Crescent Heights 1901 Minor Ave

SDCI Project # 3019623

Design Review Board Recommendation Meeting
Downtown Design Review Board

June 14, 2016

Aerial View to Southwest

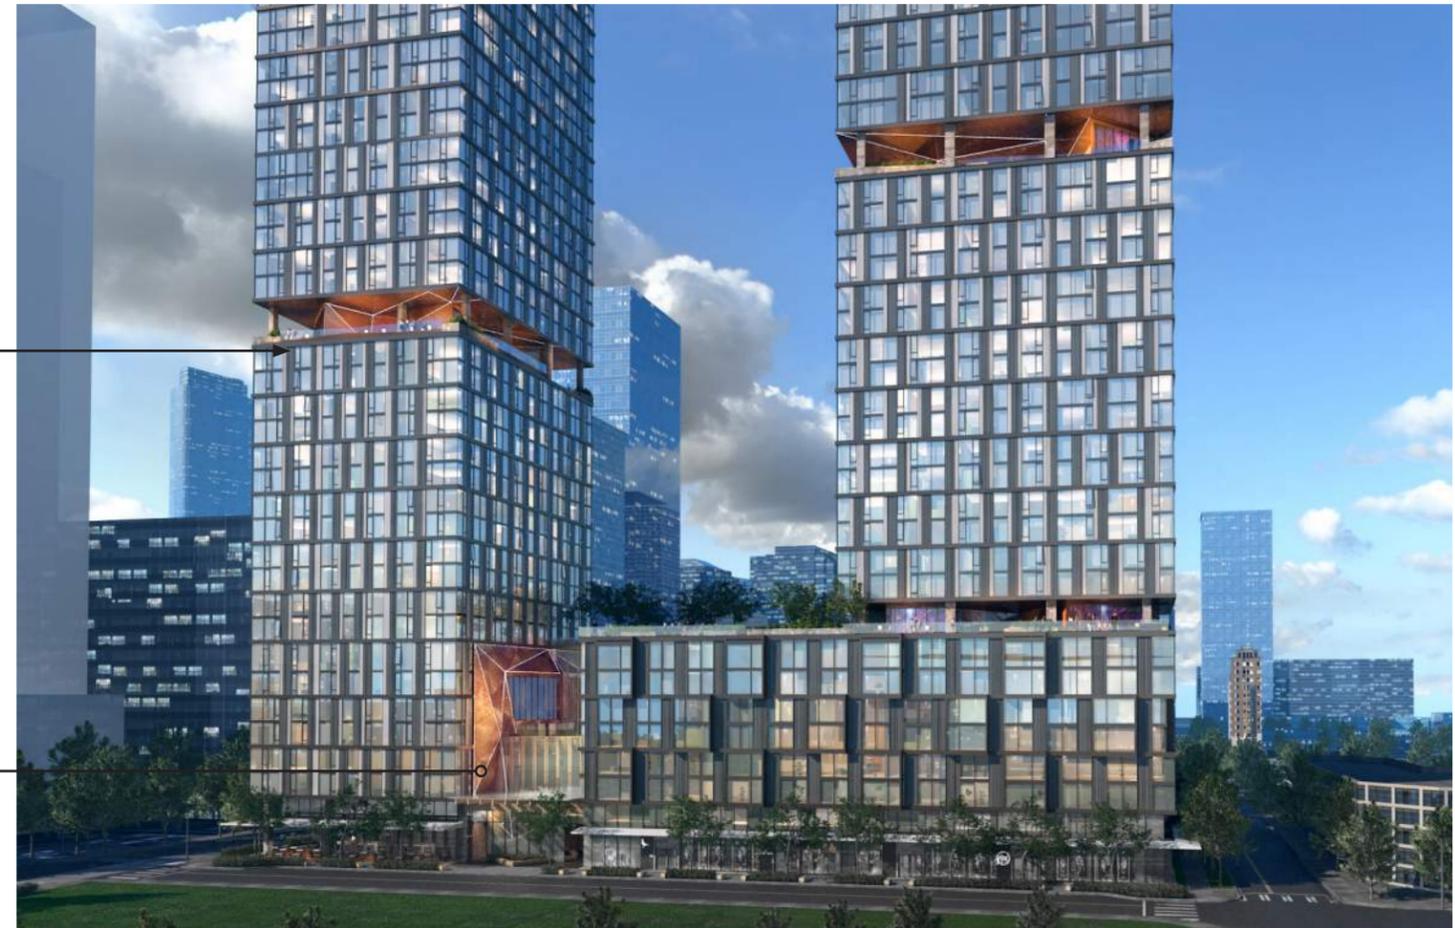
"...surrounding walls [at the courtyard] should be light color to maximize daylight..." "the south tower should integrate corridors from the core to the top of the podium terraces, so that the tower's residents can access the amenity deck..."

"The Board endorsed the concept landscape plan and program mix for the top...the variety and richness of [the precedent] images must inform..." the design development.

- The level of the courtyard has been raised one level to enhance daylight penetration. The walls of the courtyard are glazed to help reflection of daylight.
- The notch at the Minor entry has been widened to two bays. There is an additional notch at the alley side.
- Amenities are located at the ends of the courtyard, focusing on exercise and wellness.
- The top of podium and pool deck levels are accessible from each tower. A circulation loop occurs at several levels.
- Several programmatic and planting zones are provided at the top of the podium. These provide rich and varied spaces for the tenants.

Site Plan

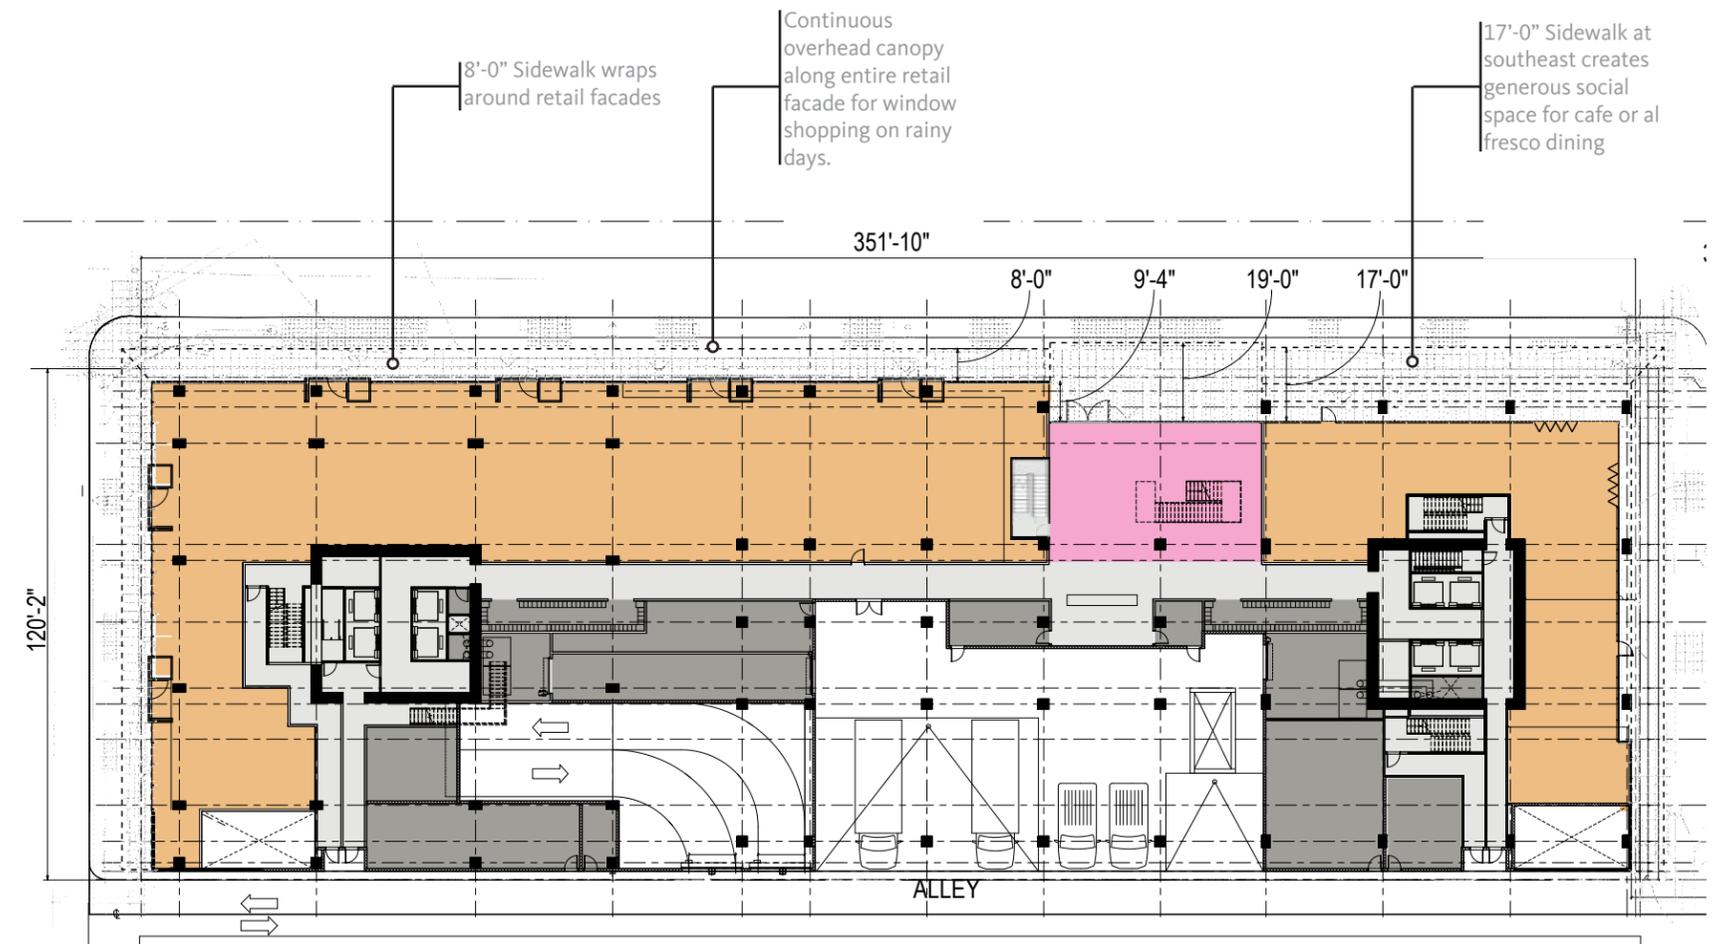
"Streetscape Design: The Board supported the 10 ft wide sidewalk along Stewart, and 12' wide sidewalk at the southeast portion of Minor, but agreed the remainder of Minor was too narrow at 6'."

The Board suggested the 8' wide curb-side planter zone be reduced, and/or columns be recessed to achieve an 8' sidewalk.

- The Southeast sidewalk has been widened to 17'-0", which will open up the corner even further and allow it to become a vibrant social gathering space
- The remainder of the sidewalk on Minor will be at least 8'-0", creating a pleasant and stroll-able promenade along the retail storefront and landscaped zone.

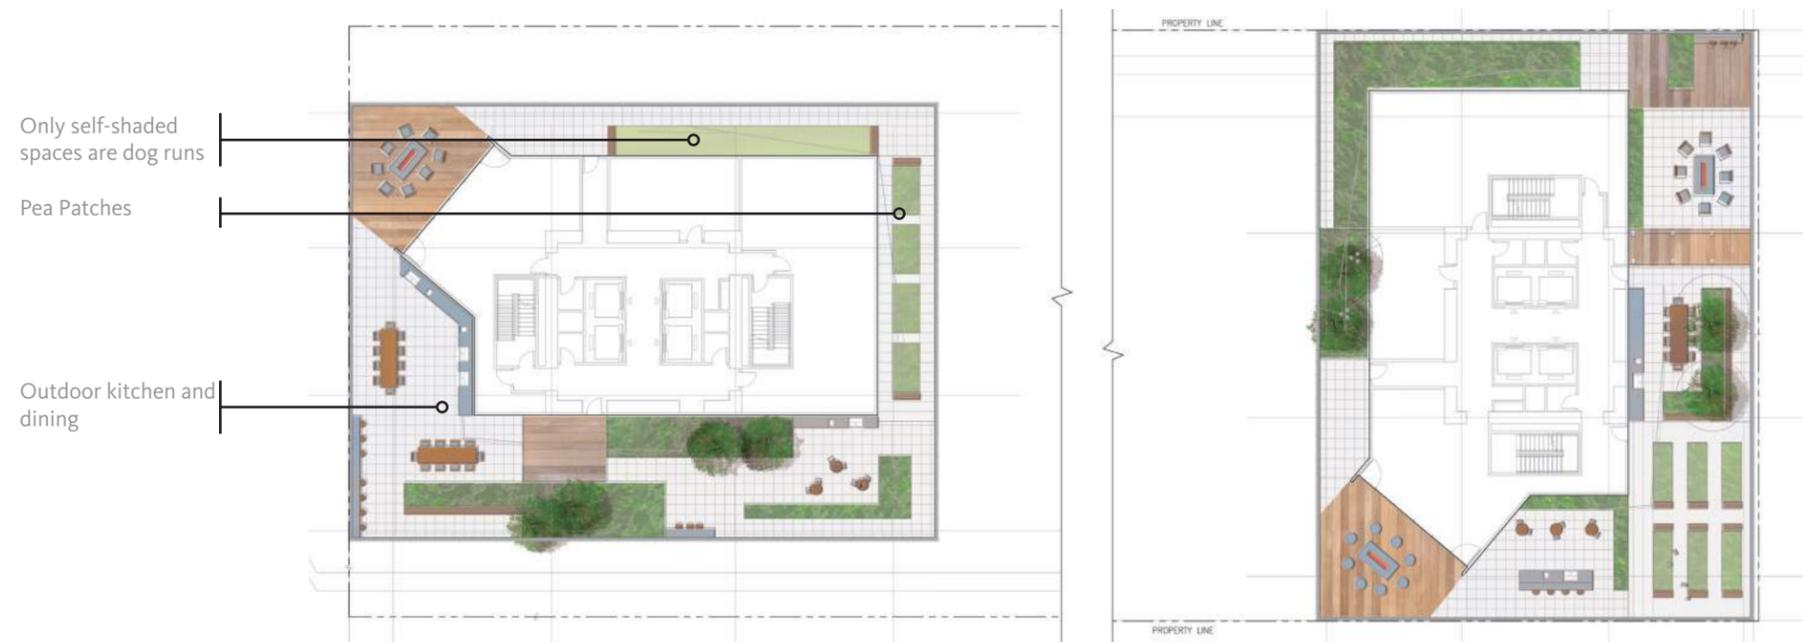
“Rooftop:... all penthouse forms should be approximately 10’ setback from all rooftop edges,...”

At least the east tower amenity should shift “to the north and east street sides, to clarify massing and minimize self-shading of the amenity spaces.”

- The form of the rooftop penthouses and amenity spaces relate to the mid-tower notches. These forms are set back with most of the mass of the enclosed space set back further than 10’ from the face of the tower.
- The penthouses are dynamic, faceted and metal-clad to provide contrast to the remainder of the building.
- Dog runs are located at the north sides of each penthouse to reduce self shading at other occupied areas.

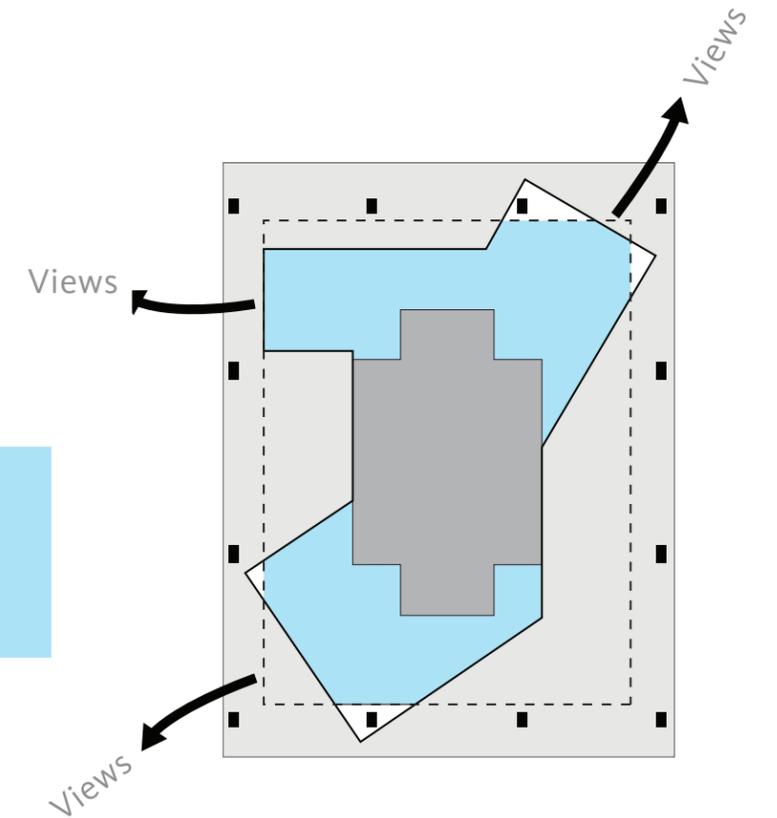
Band should be distinctly expressed
Express the columns
Explore contrast
Avoid visual fill

Relocated residential to allow for greater setbacks

Express columns by increasing depth strategically

Level 09 Floor Plan

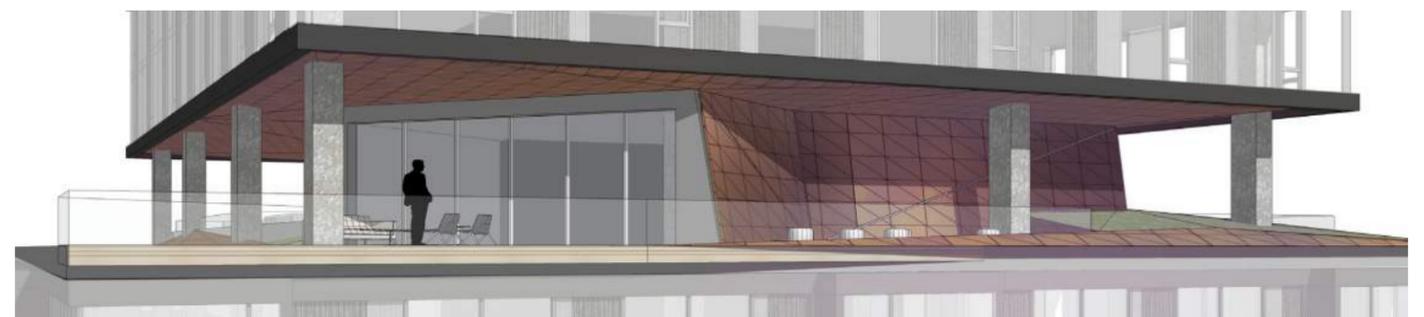
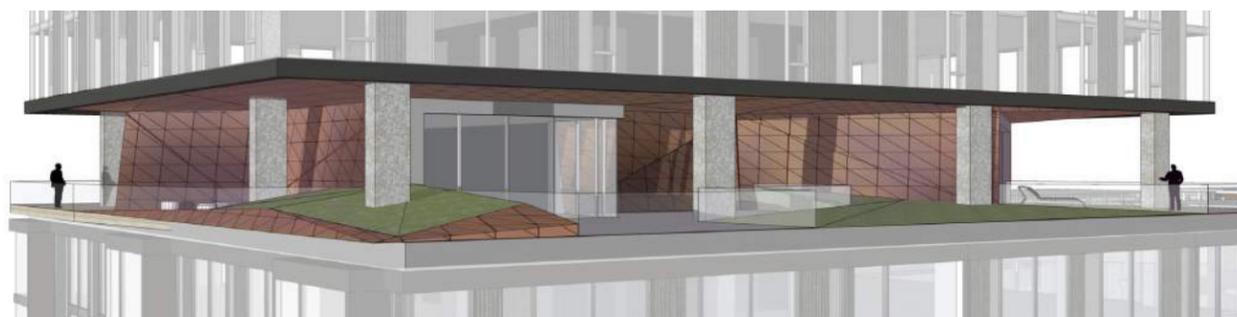
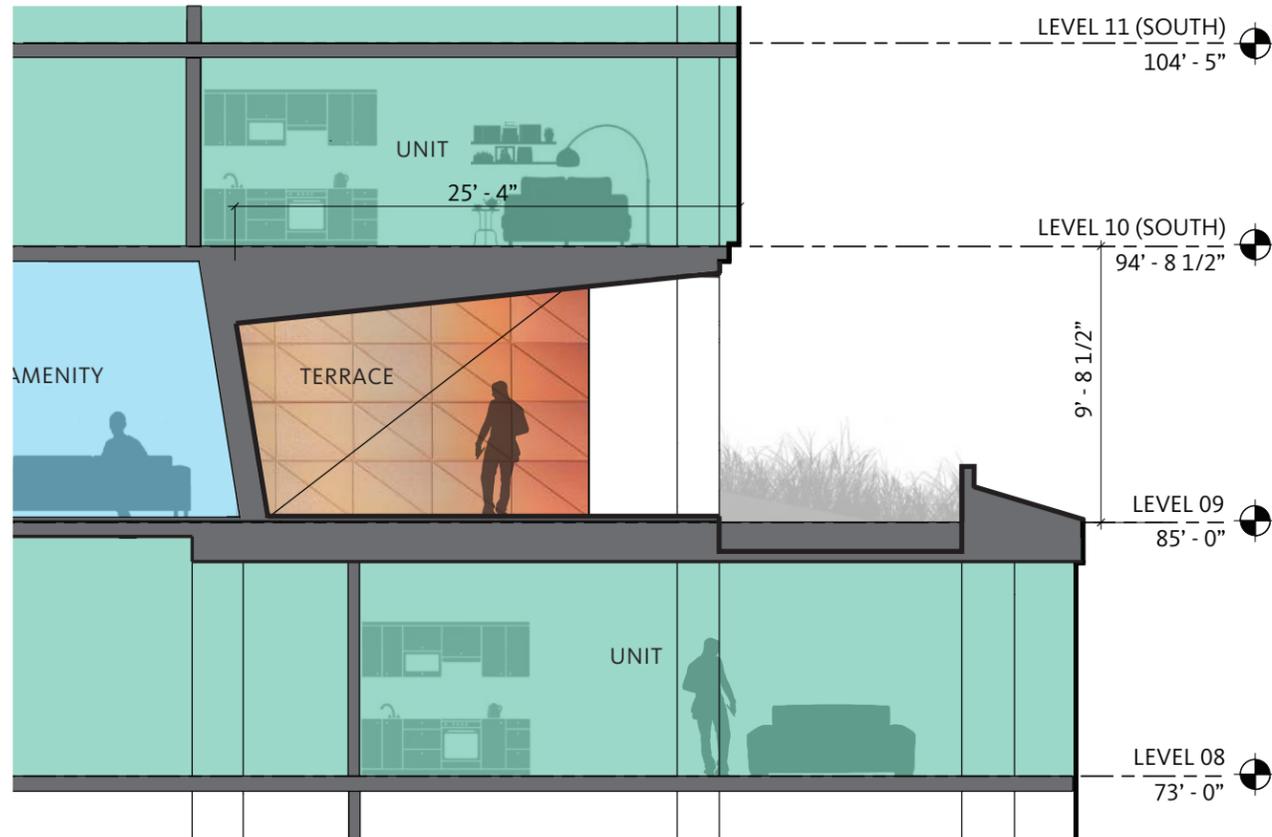
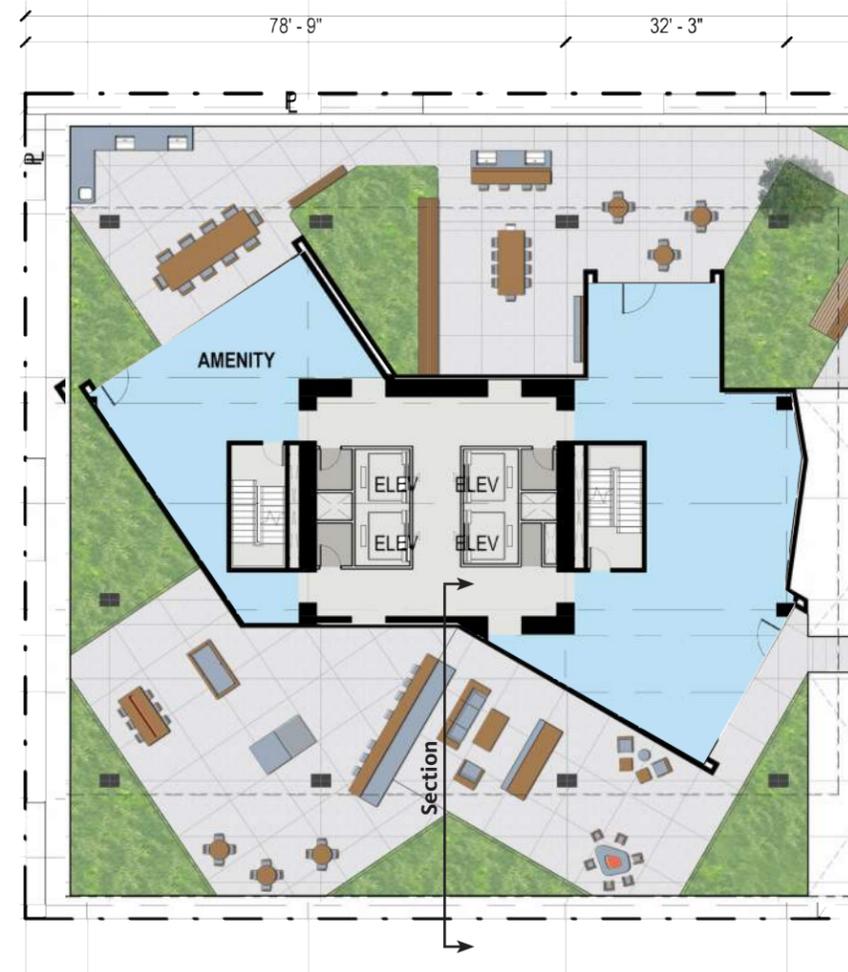
"Notches and columns: The Board agreed all exterior amenity notches should be 10' minimum depth, and...be double height"

"To create needed modulation and a legible scale of "notch" on the tall towers, the board agreed that the [notch] should wrap all four sides and be distinctly expressed as a recessed plane of contrasting materiality."

"...the depth, height and contrast of the banding is the primary objective."

- The notches are now amenity-only spaces with units relocated elsewhere.
- Amenity notches wrap all sides of the towers with most of the mass of the enclosed space set back further than 10' from the face of the tower.
- Amenity space is dynamic, faceted and metal-clad to provide contrast to the remainder of the building.
- The notches have been redesigned to be one taller floor with a 16' opening expressed at the notch perimeter. Landscape and guardrails set back from the edge to emphasize the break in the tower.

Level 21 Floor Plan

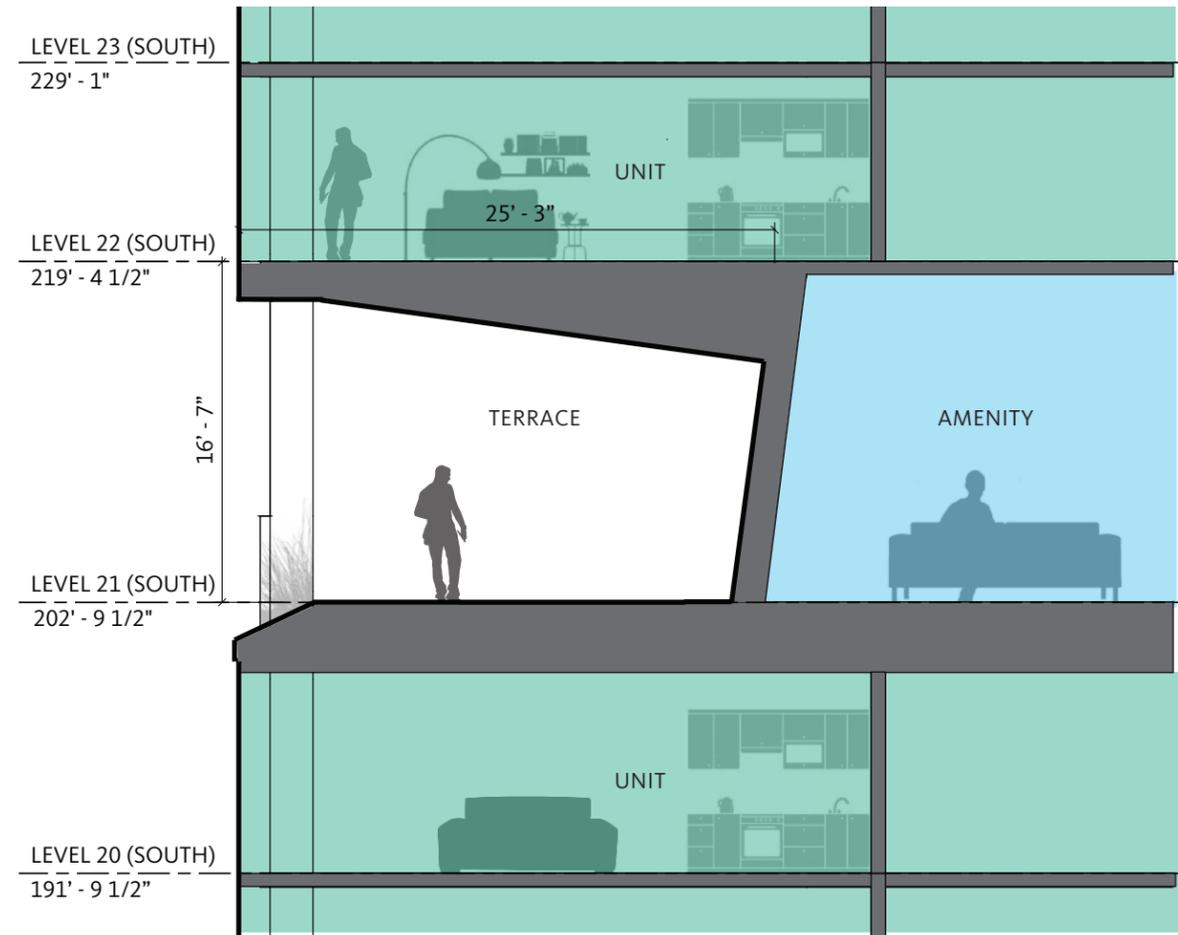
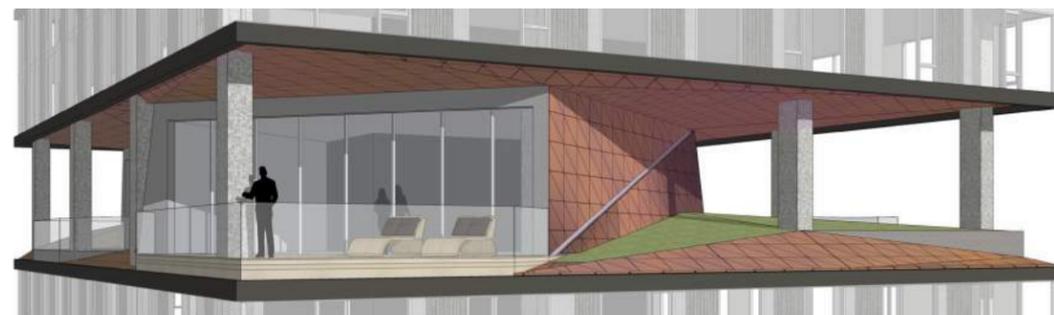
"Notches and columns: The Board agreed all exterior amenity notches should be 10' minimum depth, and...be double height"

"To create needed modulation and a legible scale of "notch" on the tall towers, the board agreed that the [notch] should wrap all four sides and be distinctly expressed as a recessed plane of contrasting materiality."

"...the depth, height and contrast of the banding is the primary objective."

- The notches are now amenity-only spaces with units relocated elsewhere.
- Amenity notches wrap all sides of the towers with most of the mass of the enclosed space set back further than 10' from the face of the tower.
- Amenity space is dynamic, faceted and metal-clad to provide contrast to the remainder of the building.
- The notches have been redesigned to be one taller floor with a 16' opening expressed at the notch perimeter. Landscape and guardrails set back from the edge to emphasize the break in the tower.
